RE: Amendment to Construction Agreement - Exhaust and Intake Modifications

We are writing to inform you of a necessary modification to our ongoing construction project at the new Carousel Arcade located at 7463 Market St., specifically regarding the new HVAC exhaust and intake locations as shown in the updated architectural drawing sheets dated 02/27/24 and sheets labels A3.0& M1.2 that are attached to this document.

SHEET:
A3.0

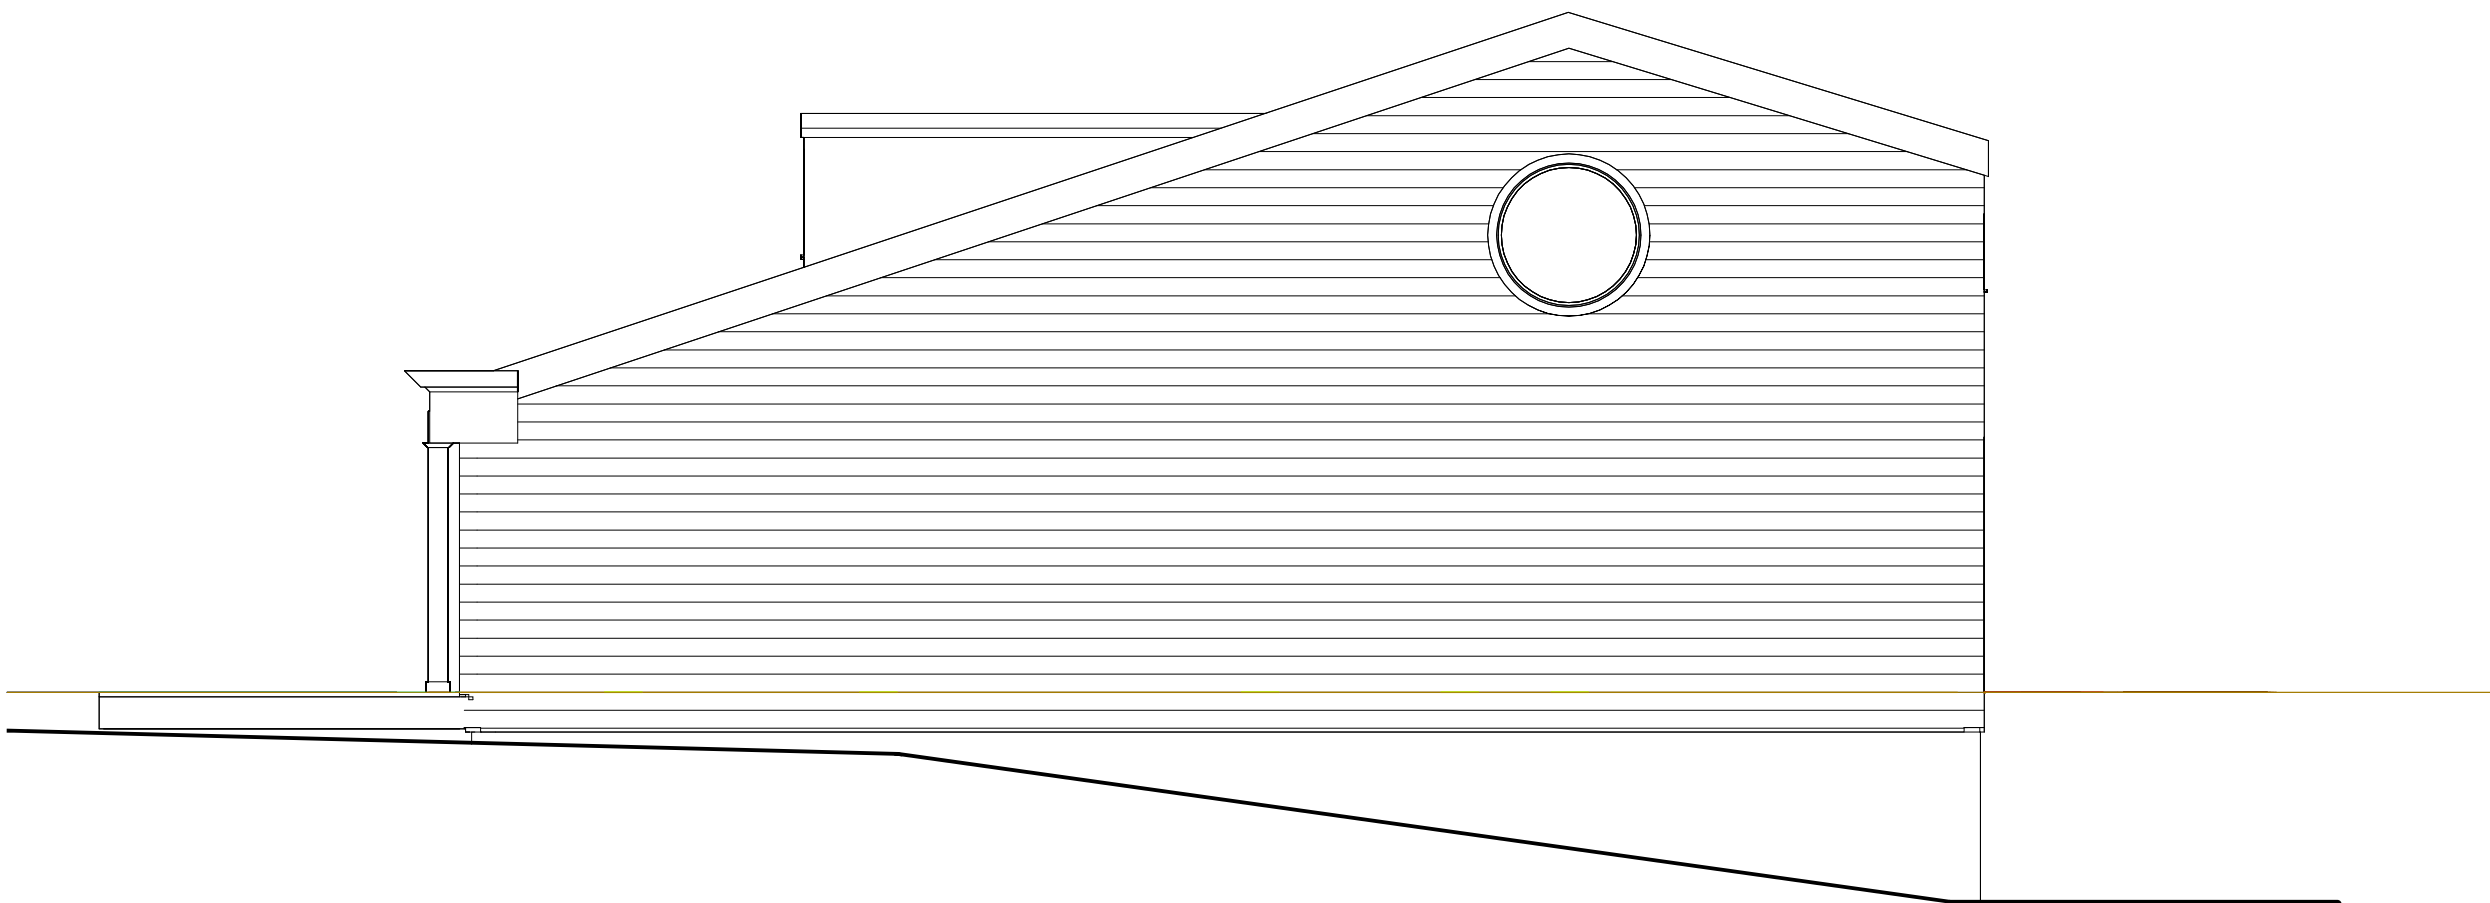
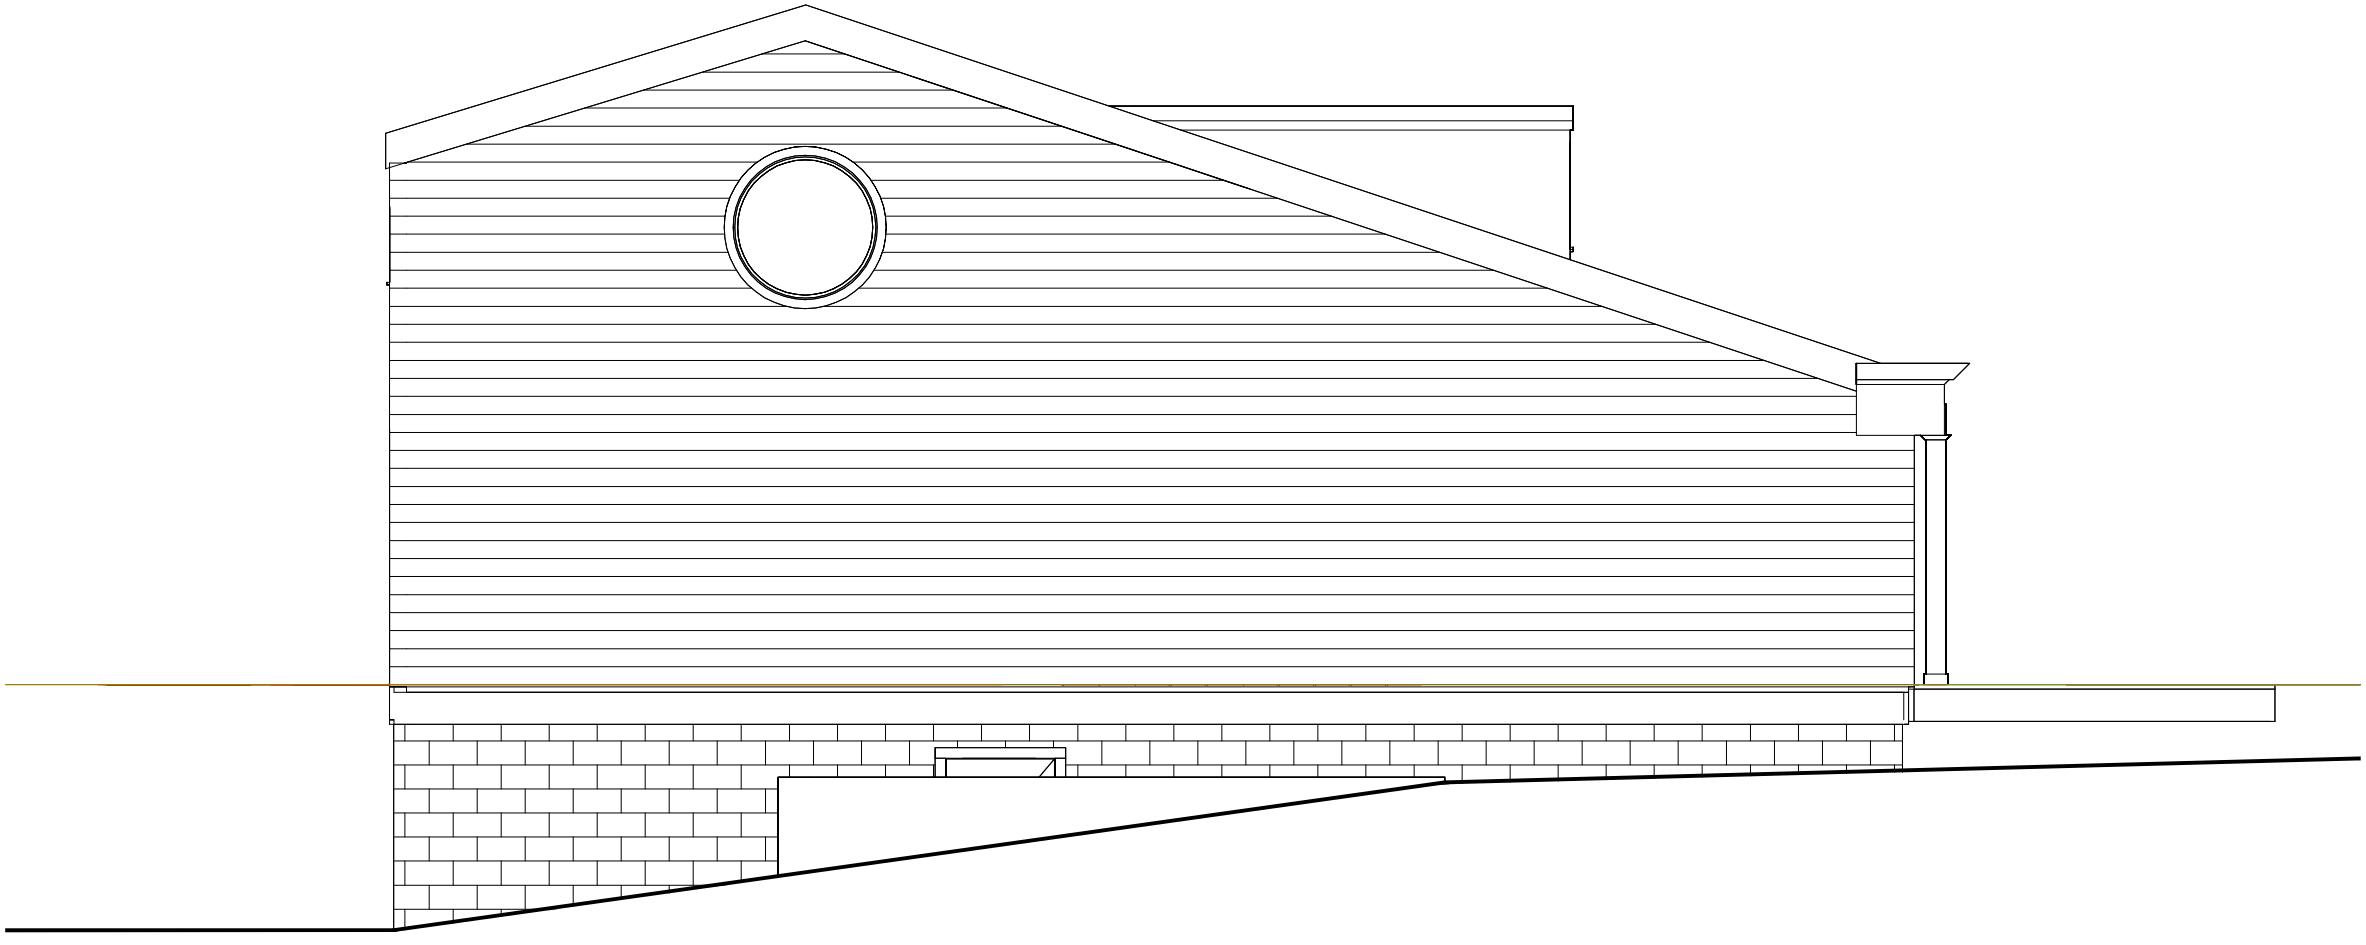
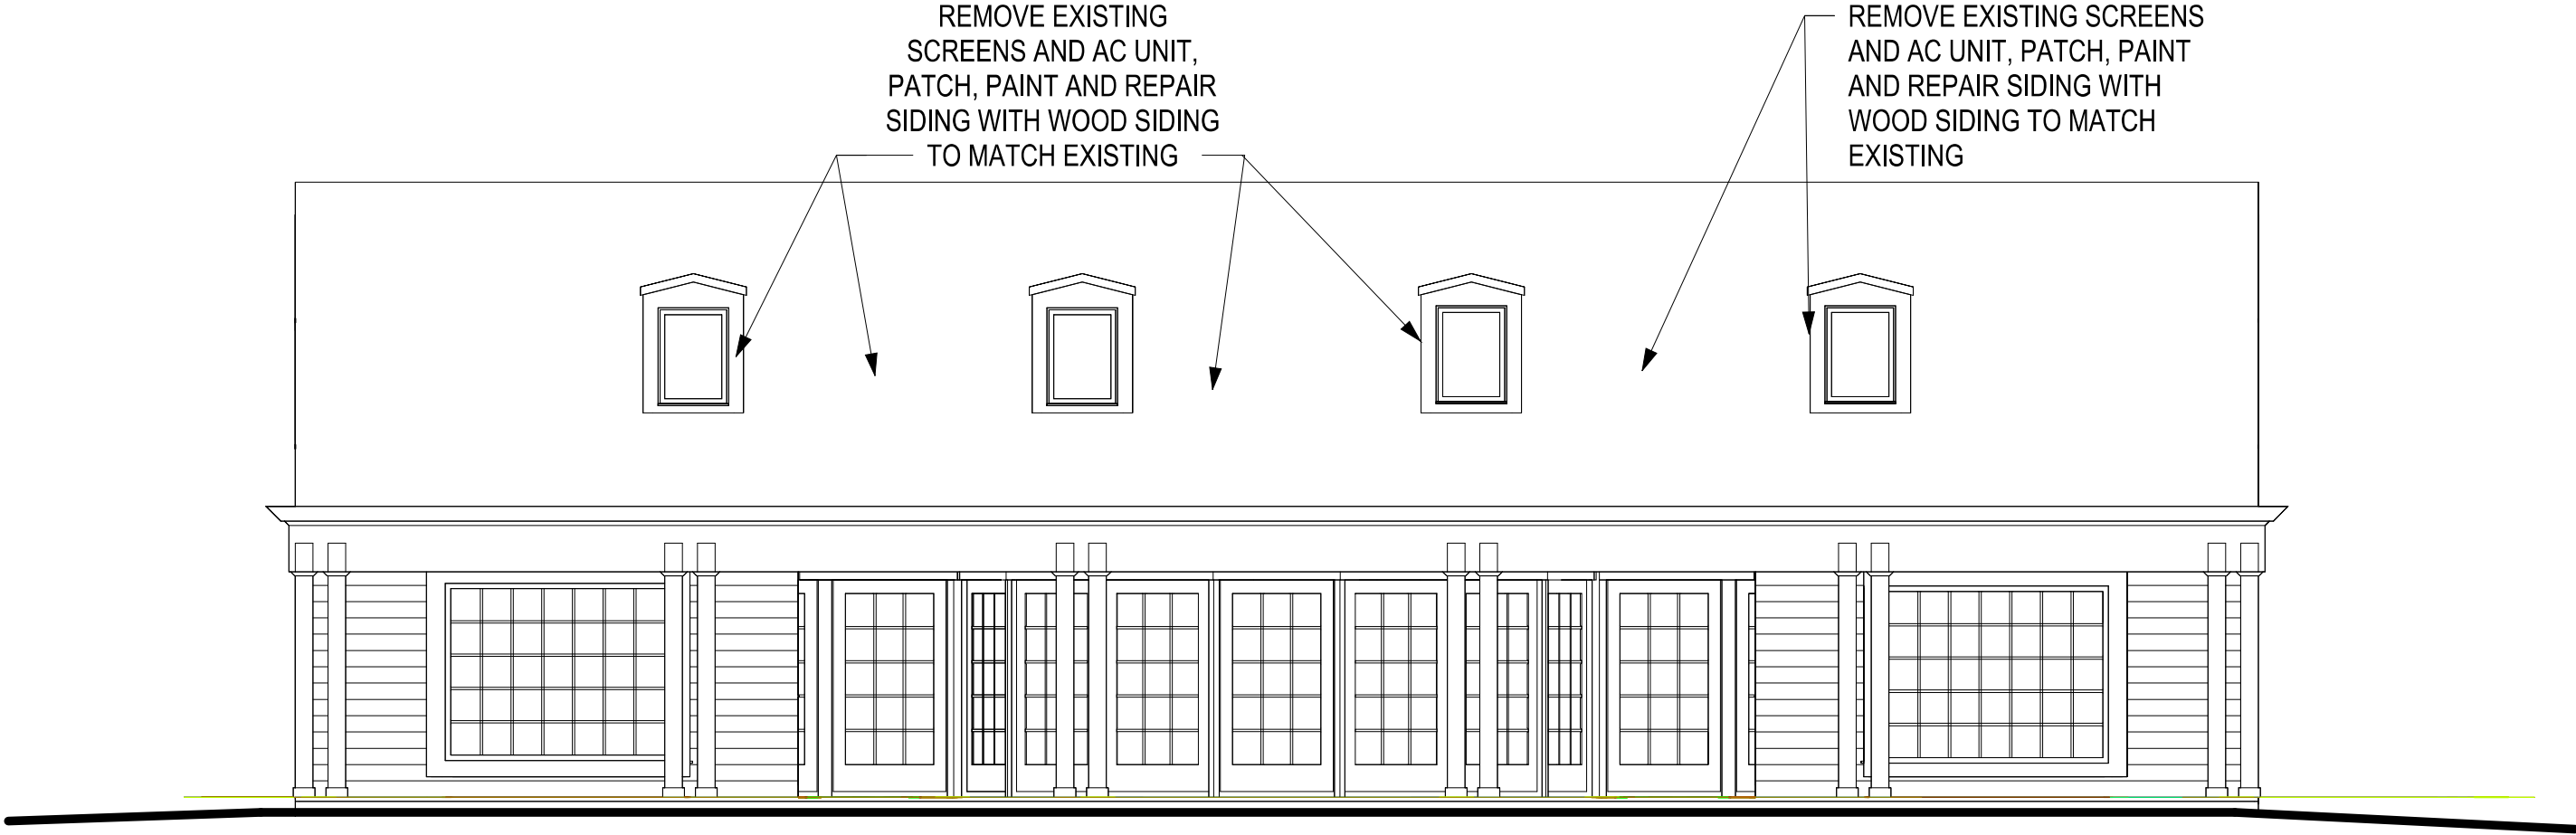
The original permit drawings called for a new HVAC system with the intake and exhaust louvers utilizing existing openings where we removed the old A/C units located on the rear of the building, next to multiple of the existing operable windows, which the owner of the building still plans on utilizing in the future. Upon review of Michigan building code regulations, it has been brought to our attention that the new air exhausts and intake vents cannot be installed near functioning operable windows to be compliant with the state regulations.

1. **Relocation of Exhaust and Intake:** We will relocate the exhaust and intake system to the northeast side of the rear of the building and install per Michigan building code requirements.
2. **Window Modification:** To facilitate the relocation and ensure proper functioning of the system, the window adjacent to the intake will be permanently pinned and sealed closed. This modification is essential to prevent any interference with the system's operation.
